**Appeal Submittal:
City of Key West, FL
Appeal of FEMA's Preliminary Flood Insurance Rate Maps
and Flood Insurance Study
(issued 12/27/2019)**

May 2021

Prepared for:
City of Key West
1300 White Street
Key West, FL 33040

Prepared by:
Woods Hole Group
A CLS Company
107 Waterhouse Road
Bourne, MA 02532 USA
(508) 540-8080

Figure 9. Example of lack of sufficient model resolution – Harris Channel. Panel (a) shows aerial image and panel (b) shows the model mesh overlaid on color contours of elevation (yellow to red colors represent overland areas > 0 ft in elevation relative to NAVD88).

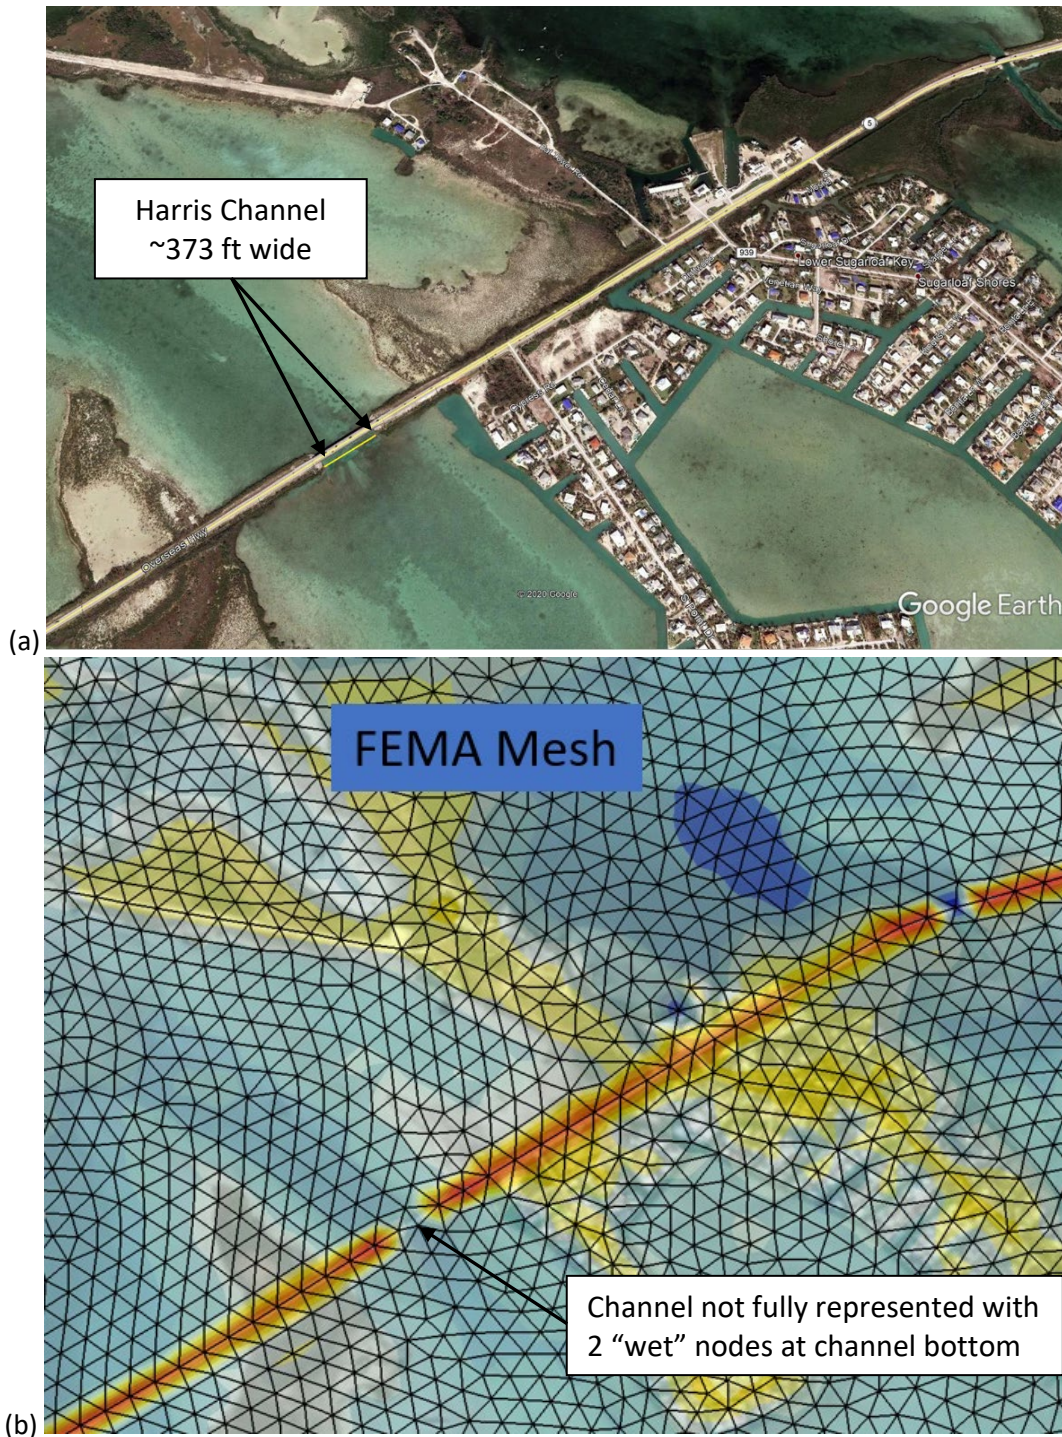
Issues related to the ADCIRC+SWAN hydrodynamic/wave model mesh were identified at seven (7) channel locations throughout the Keys. The model mesh was not resolved to sufficiently represent the hydraulic capacity of the channels and allow conveyance of storm surge and waves during simulated storms. These were errors or oversights made in the mesh developed for the Keys. This issue was communicated to FEMA in correspondence dated May 4, 2020. FEMA responded in their June 11, 2020 correspondence that these were not errors but rather the modelers chose to not fully represent these channels because the target mesh resolution (distance between model nodes) for the Florida Keys was 250 feet. Additionally, FEMA stated that, “The request to improve conveyance pertains to a higher level of detail analysis that falls outside of current scope of the Flood Study.”

Table 3 lists the seven (7) channels that lacked sufficient resolution in the model along with the channel widths. Figures 8 and 9 show examples of channels in the Keys that were not fully represented (further examples are presented in Appendix A, Attachment B). Most of these channels have widths at or greater than 250 feet, the target resolution. Even if these channels are smaller than the target resolution, consideration should have been given to represent the primary channels in and around the Keys to an appropriate level of resolution to be technically correct in conveying storm surge. The City does not believe this falls outside the scope of FEMA’s study.

As part of the City’s review, the storm surge and wave model resolution was increased where it was found to be insufficient at the channels listed in Table 3. This resulted in only 75 additional nodes added to the model mesh (total of 2,249,168 nodes). A single production storm was first run (storm 113) to assess the potential impacts of the lack of resolution. Storm 113 was selected as it tracked within the middle portion of the Keys and had a substantial contribution to the 1%-annual-chance water levels developed by FEMA. Comparisons with FEMA’s results showed local differences in maximum storm surge on the order of 0.4 to 1.6 feet (see Appendix A, Attachment B for further details). This indicates the importance of adequately resolving these channels, and that FEMA’s model results are scientifically incorrect because the model resolution used was inappropriate.

This issue related to insufficient model resolution and representation of hydraulic pathways was addressed by increasing the storm surge and wave model resolution where it was found to be insufficient. The updated model was revalidated and then used to simulate a subset (46 storms) of FEMA’s defined JPM-OS synthetic storm set. Further details are provided in Appendix A. The results from these storm runs were then incorporated into the statistical analysis of water levels and waves that affect the 1%-annual-chance base flood elevations. Updated overland wave modeling and floodplain mapping were then conducted using these updated 1% wave and water levels, as detailed in Appendix C.

Figure 10. Differences in maximum storm surge between FEMA’s model and the updated model configuration for Production storm 113.

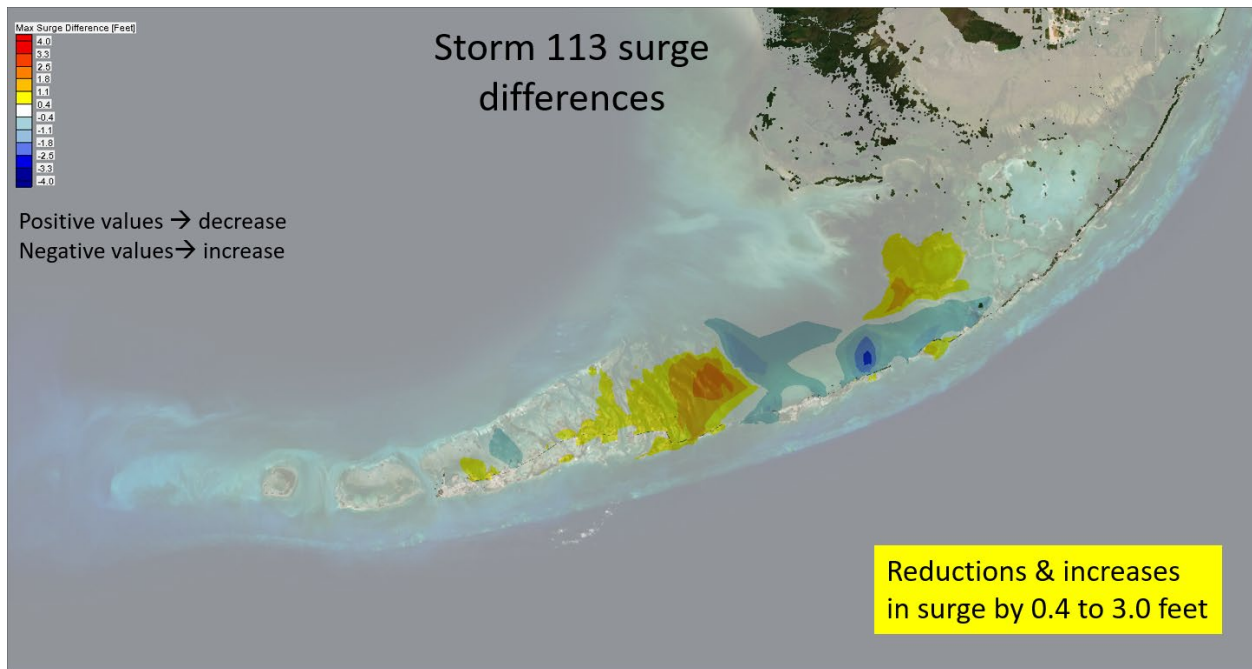
When characterizing reefs in the ADCIRC+SWAN hydrodynamic/wave model, FEMA used friction values at the lower end of what is recommended by the scientific literature. Since friction created by the reefs acts to dissipate the amount of wave energy reaching the shoreline, this issue has a significant impact on the predicted storm wave conditions, wave setup, surge, and the subsequent overland wave modeling and flood zone mapping.

The City’s review of recent studies relevant for determining bottom roughness coefficients for reef features indicates the appropriate range in Manning’s n frictional coefficients for reefs is from 0.04 to 0.35 (further detailed in Appendix A, Attachment A). FEMA specified a Manning’s n value of 0.035 to 0.05 for reefs which is below or at the low end of the applicable range for reefs. However, the study provided by FEMA (Nelson, 1996) also suggests using a higher frictional value than FEMA applied for reefs.

As part of the City’s review, the model’s sensitivity to the frictional coefficient was assessed by increasing the Manning’s n value for reefs from 0.035-0.05 to 0.1. Again, a single production storm was run (storm

113) to assess the potential impacts on model-predicted water levels and wave conditions. Comparisons with FEMA’s results showed regional differences extending out from the storm track in maximum storm surge on the order of 0.4 to 3.0 feet (see Figure 10). In addition, peak wave heights occurring during the storm were reduced by 0.5 to 0.9 feet and this reduction was shown to occur across a broader extent of the Keys, as shown in Figure 11.

The inappropriate assumptions used for characterization of reef features was addressed by adjusting the roughness parameter assigned to reefs in and around the Keys to a more appropriate median value (Manning’s n value of 0.07). Additionally, the City updated the extent of the reefs represented in the model using the latest Florida Fish and Wildlife Conservation Commission Unified Reef Map (Baumstark, 2013). See Appendix A, Attachment A for details on the literature review and application of a medium value of bottom roughness value for reef features. The updated model was revalidated and then used to simulate a subset (46 storms) of FEMA’s defined synthetic storm set (see Appendix A). The results from these storm runs were then incorporated into the statistical analysis of water levels and waves that affect the 1%-annual-chance base flood elevations. Updated overland wave modeling and floodplain mapping were then conducted using these updated 1% wave and water levels, as detailed in Appendix C).

Figure 11. Differences in maximum wave height between FEMA’s model and the updated model configuration for Production storm 113.

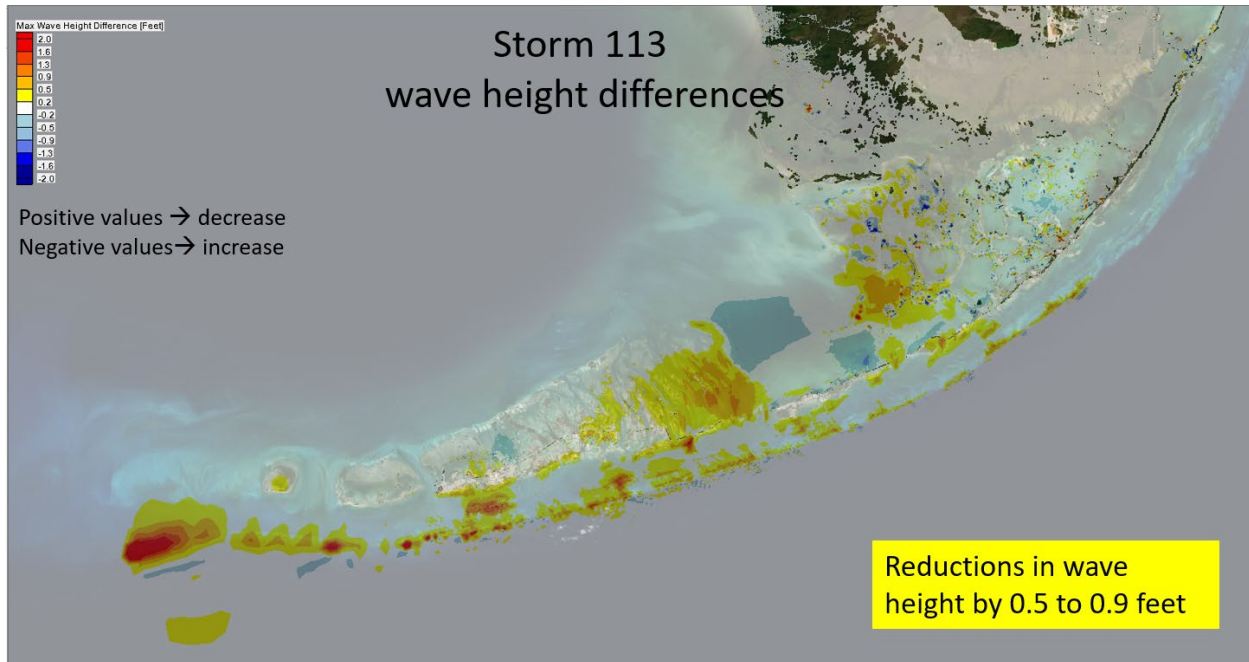
This indicates the model’s sensitivity to the frictional coefficient applied to reef features. Given the lack of wave model validation (discussed in Section 4.3), FEMA’s applied frictional coefficient for reefs is not appropriate based on the latest scientific literature. Applying a mean or median bottom roughness value based on the prior studies founded on field studies is more scientifically correct in this instance.
